Public Notice

B. Name of Subdivision: Wyndmoor Court

July 27, 2021
Mark Penecale, Planning Director
Springfield Township
Reference: Wyndmoor Court – Two Lot Subdivision Application

Re: MCPC # 21-0199-001
Plan Name: Wyndmoor Court
(1 lot comprising 2.042 acres)
Situate: 7602 Pine Rd: East Ln (N) Ivy Hill Road (S)

LAND DEVELOPMENT - RECORD PLAN FOR

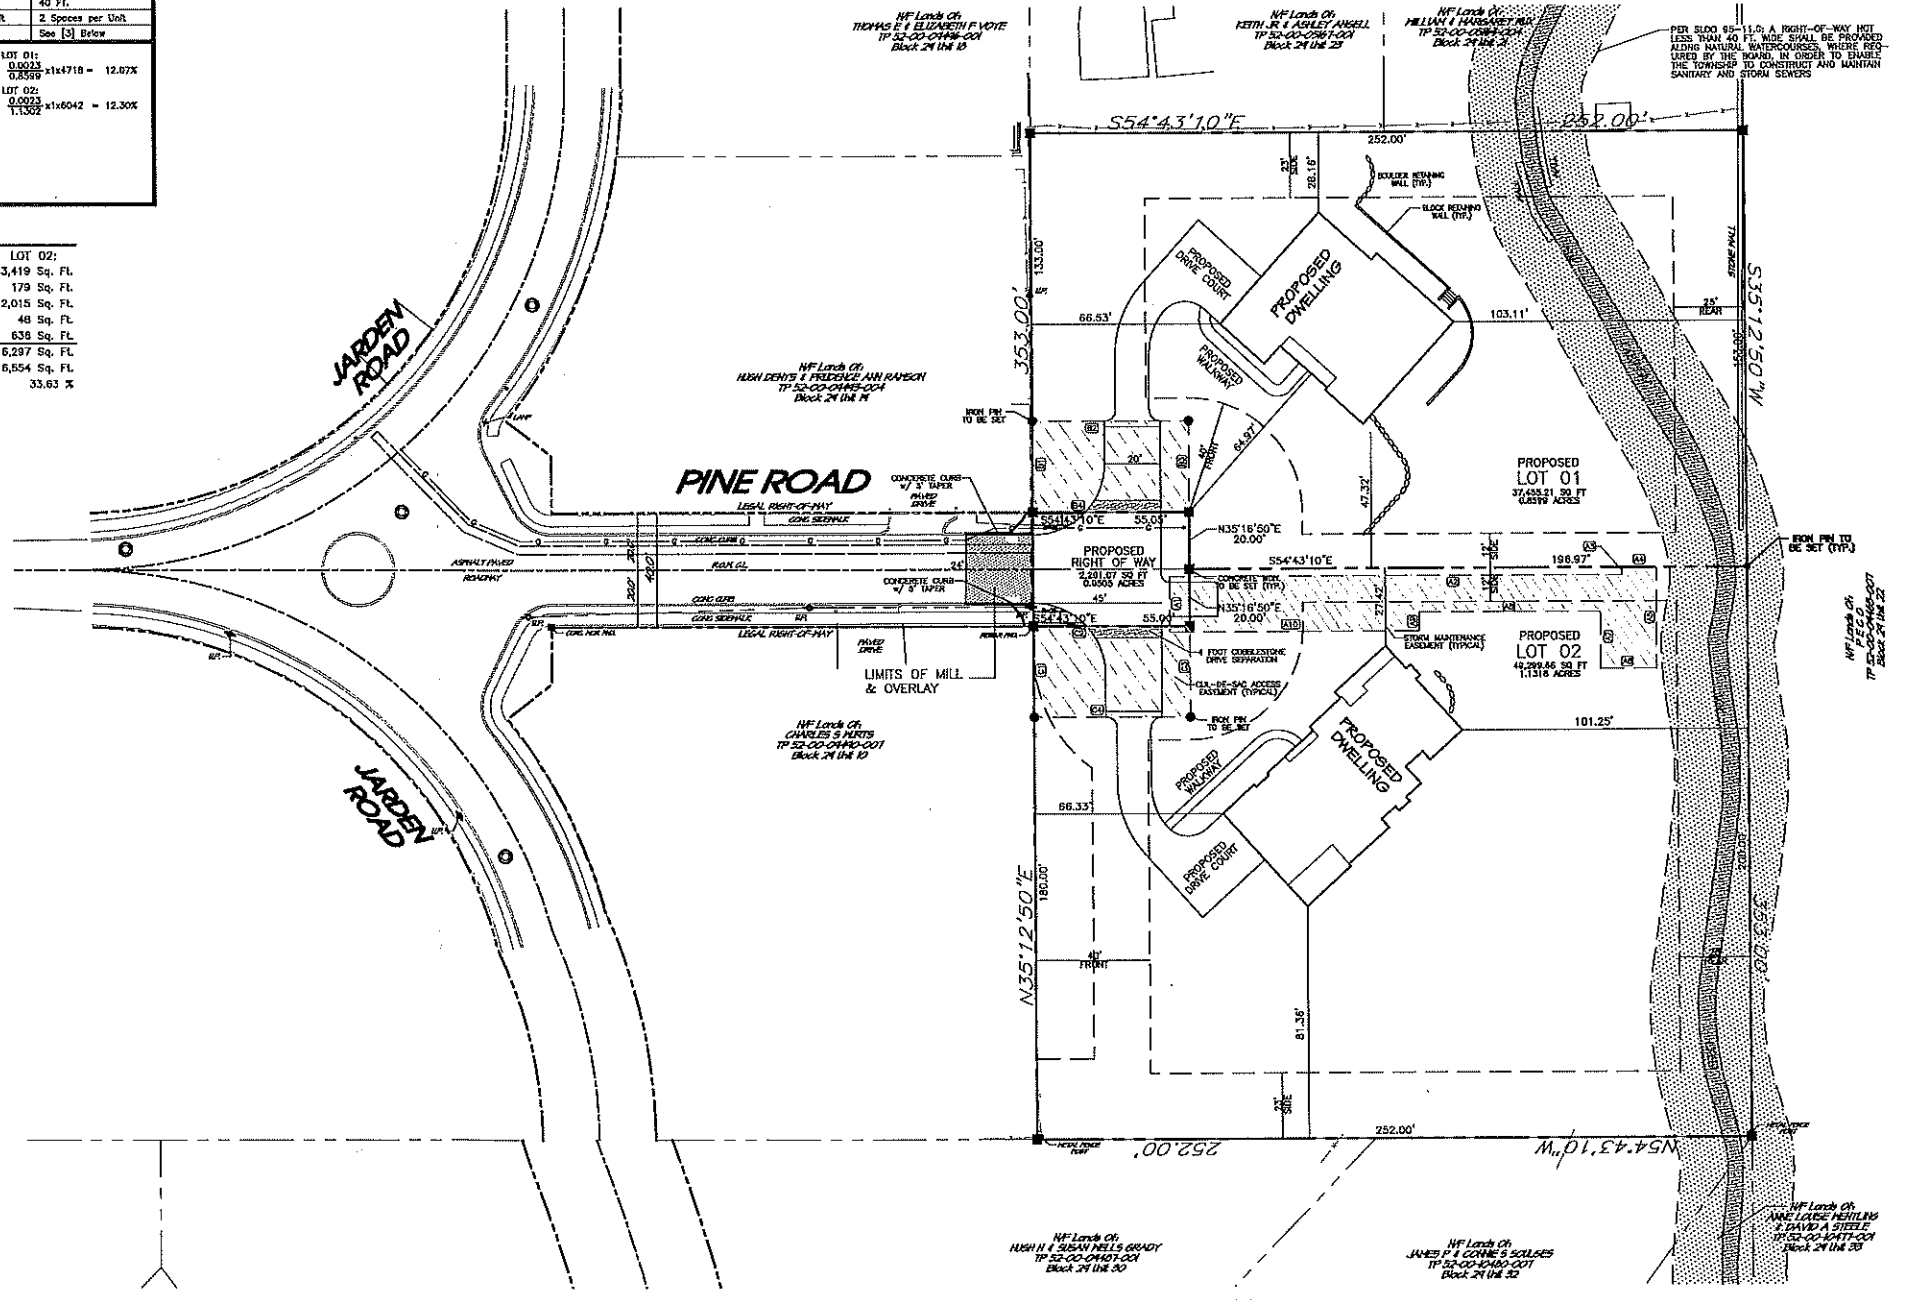
1. Note Number One of the General Plan Notes found on Sheet No. 2 appears to show the address of the owner versus the address of the property. This note should be amended.

3. On the 'Land Development – Record Plan', Sheet 2, it appears an additional stormwater maintenance easement will be necessary for the proposed Level Spreader area.

4. On the 'Land Development – Record Plan', Sheet 2, it appears the adjoining side yard setback between Lot 1 & 2 is incorrectly labeled as 23' and in fact should be labeled as the minimum side yard setback of 12'.

1. The site address in note 1, sheet 2 has been corrected.
2. Construction fencing has been added to the plan to delineate the disturbance area as requested.
3. The stormwater easement has been revised to encompass the level spreader.
4. The side yard setback labels have been corrected.
5. Proposed features are eliminated from the legend on the existing features plan.
6. The stone trench for Basin A has been expanded to 10 feet and the detail is revised accordingly.
7. The Lot 1 StormTank detail labels are corrected.
8. The stormwater routing calculations are revised to use a design safety factor on the exfiltration rates.
9. Erosion Control Items

EXISTING FEATURES AND DEMOLITION PLAN FOR

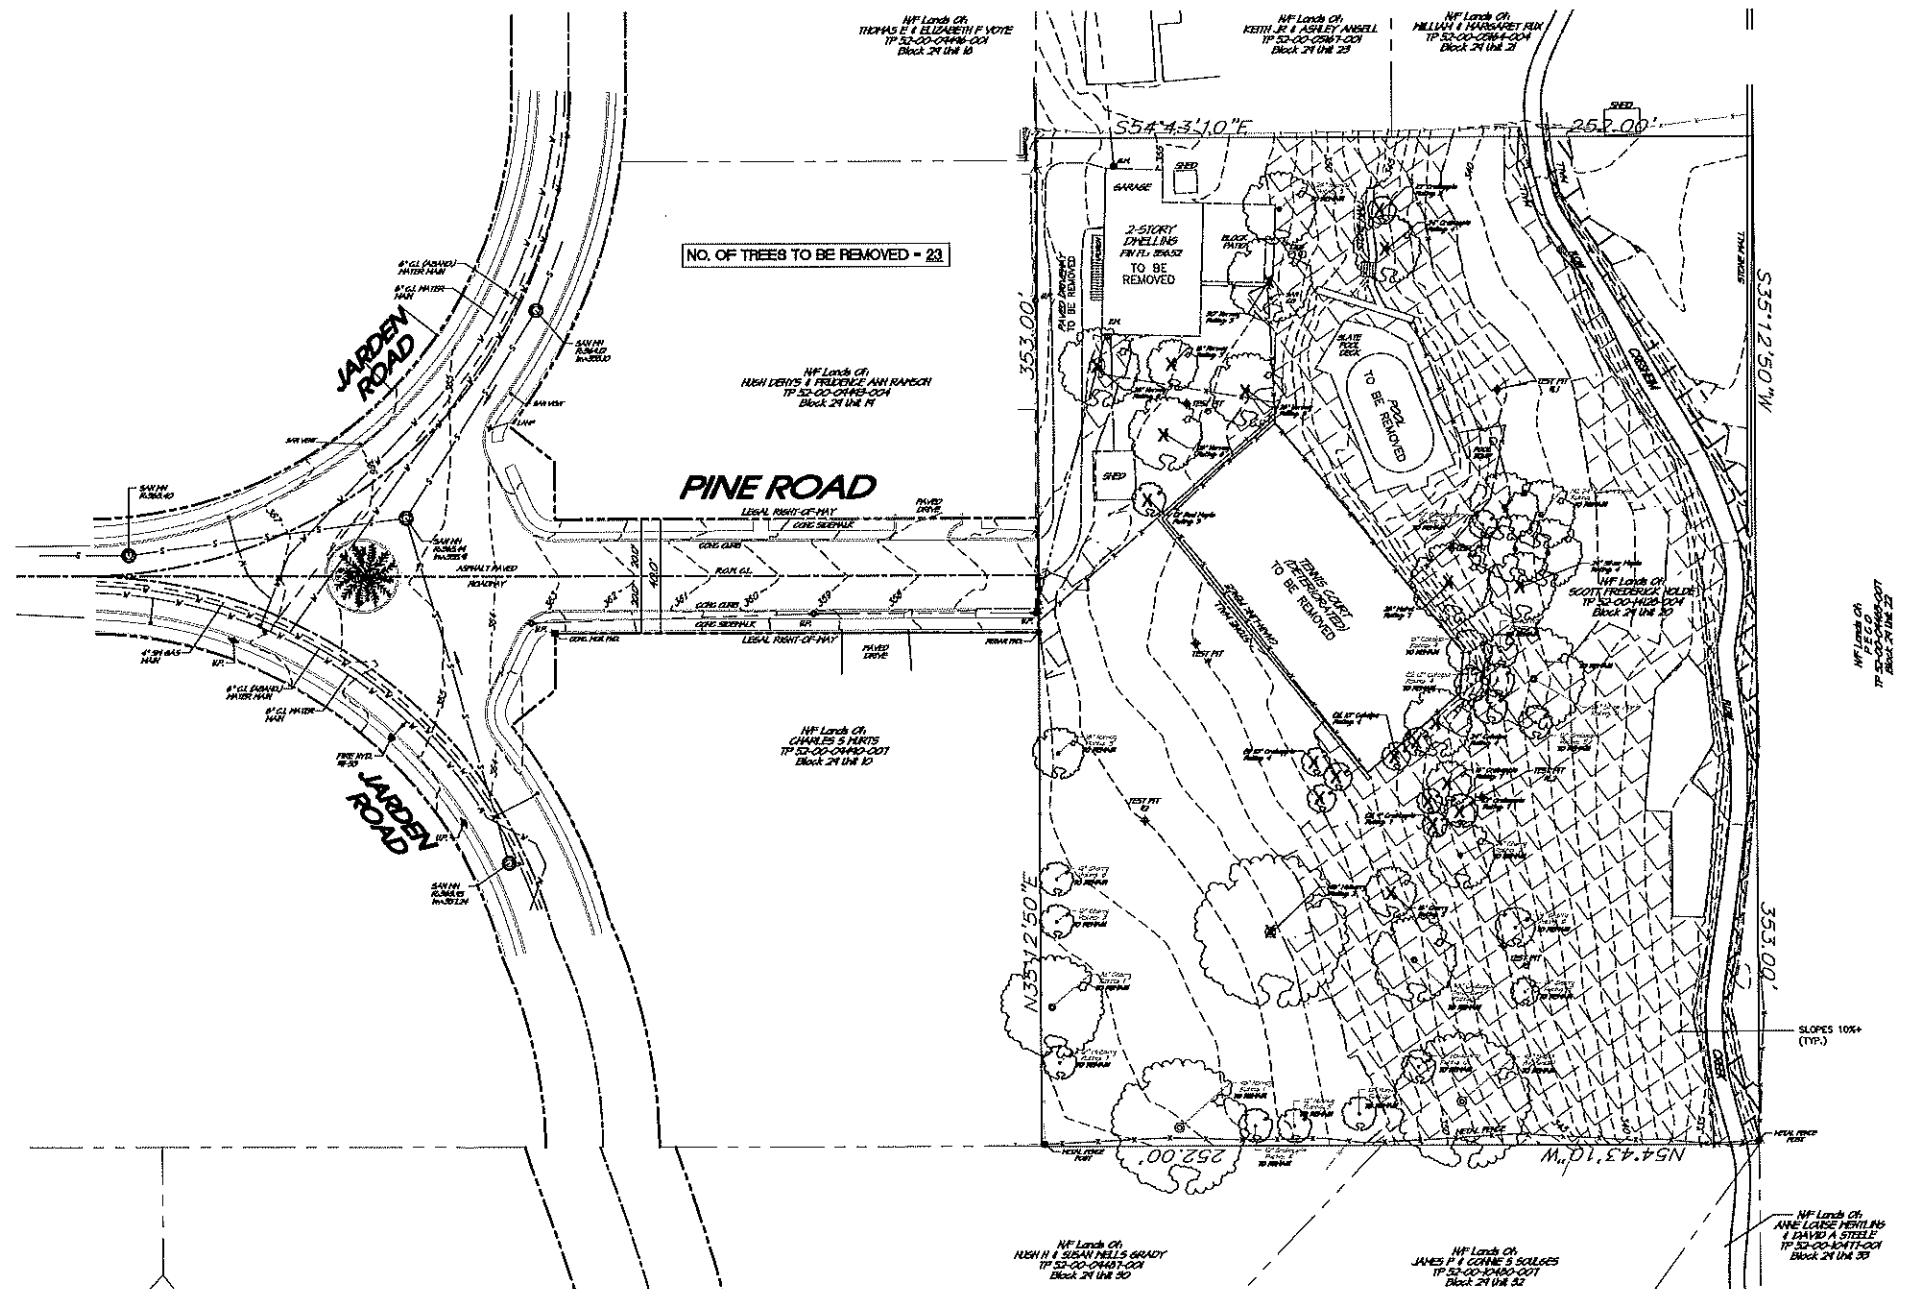
2. Chapter 95-7.G.(1) – Requires areas of slopes of 10% or greater to be shown on the plan. The Existing Features & Demolition Plan (Sheet 3) must identify all areas onsite with a slope of 10% or greater. While the plan describes the slopes in excess of 10%, additional plan information must be provided to detail the amount of slopes disturbed versus the amount of slopes protected.

Slopes 10% and greater have been graphically added to the 'Existing Features and Demolition Plan', however, the requested additional plan information pursuant to Article XIIB – Regulations for Areas of Steep Slopes has not been added to the plans.

5. The Plan Legend on the 'Existing Features and Demolition Plan', Sheet 3, contains proposed features, these should be removed.
6. The 'Underground Basin 'A' – Section Detail' on Sheet 10 of the Plan Set notes an 8.0' wide trench, however, mathematically and within the Storm Report this trench is noted as being 9.5' wide, please revise.

1. Sanitary and Storm Sewer profiles are provided on the plans.
2. The plan is updated to provide slope information in accordance with Article XIIB.
3. An accounting of the number of trees for removal has been added to the plans (See sheet 3 of 10).
4. Once the Township is satisfied that the technical comments re addressed, the seals, including the Landscape Architect Seal will be affixed to the plan.
5. As noted, the turnaround configuration has been approved by the Commissioners.
6. The handicap ramps are depicted and noted on sheet 4 of 10 and details for construction have been added to sheet 4.

SITE IMPROVEMENT PLAN FOR WYNDMOOR COURT FINAL SUBDIVISION PLAN

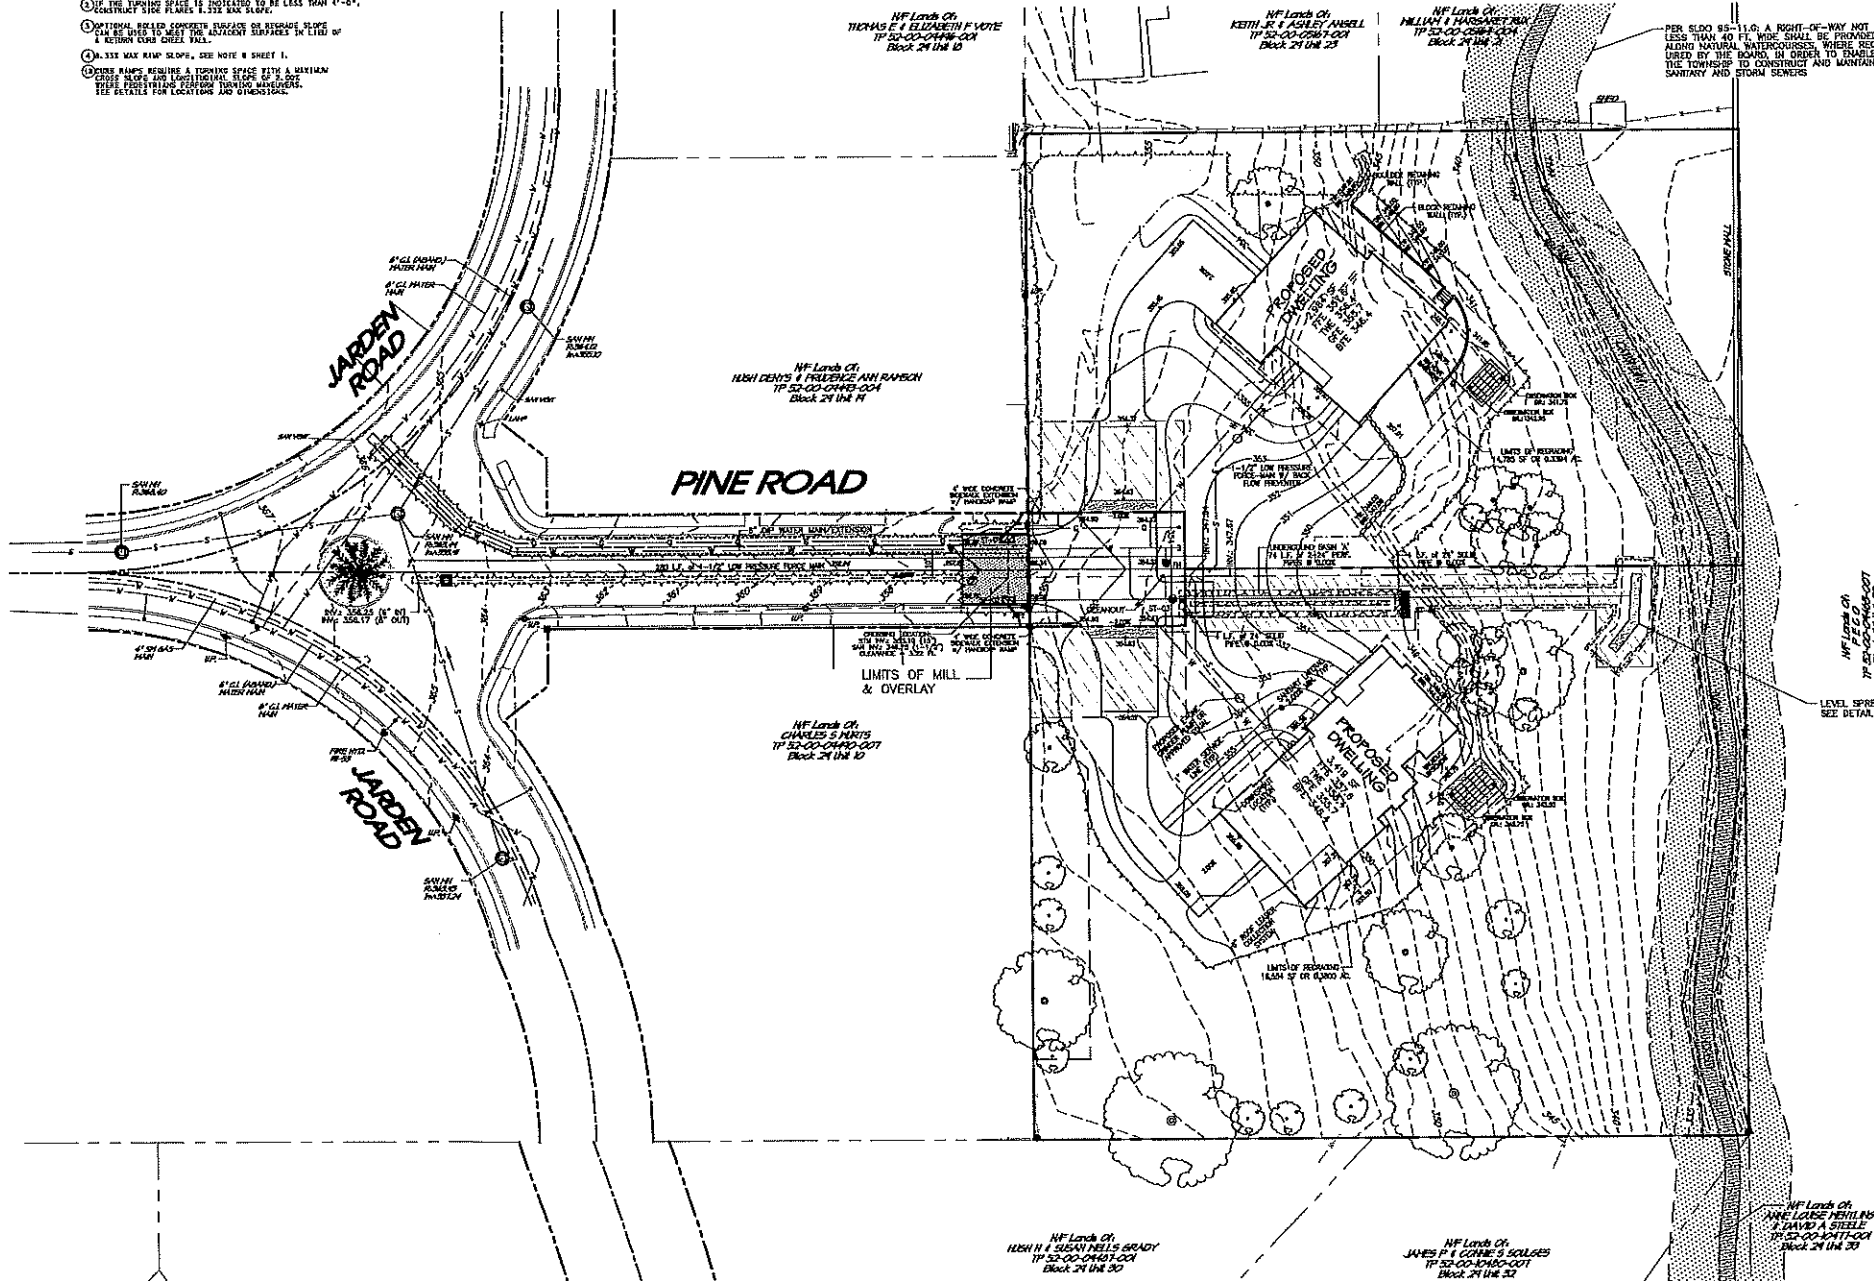
11. On the 'Site Improvements Plan', Sheet 4, the Structure Schedule information lists an Endwall ST-05, however, this endwall does not appear to be shown on the plan set. There is also a pipe run in the Stormwater Piping Schedule indicating a pipe from Inlet ST-04 to Endwall ST-05.

13. On the 'Site Improvements Plan', Sheet 4, the pipe length from ST-03 to ST-04 appears to have a combined length of the single 24" solid pipe, twin-24" perforated pipes, and single 24" solid pipe outlet to ST-04, the Stormwater Piping Schedule should be revised to provide further clarity in these pipe lengths and connections.

13. The pipe schedule on sheet 4 is amended to distinguish between the perforated and solid piping between ST-03 and ST-04.
 14. Additional information for the inflow pipe on the level spreader detail has been added to the plans.
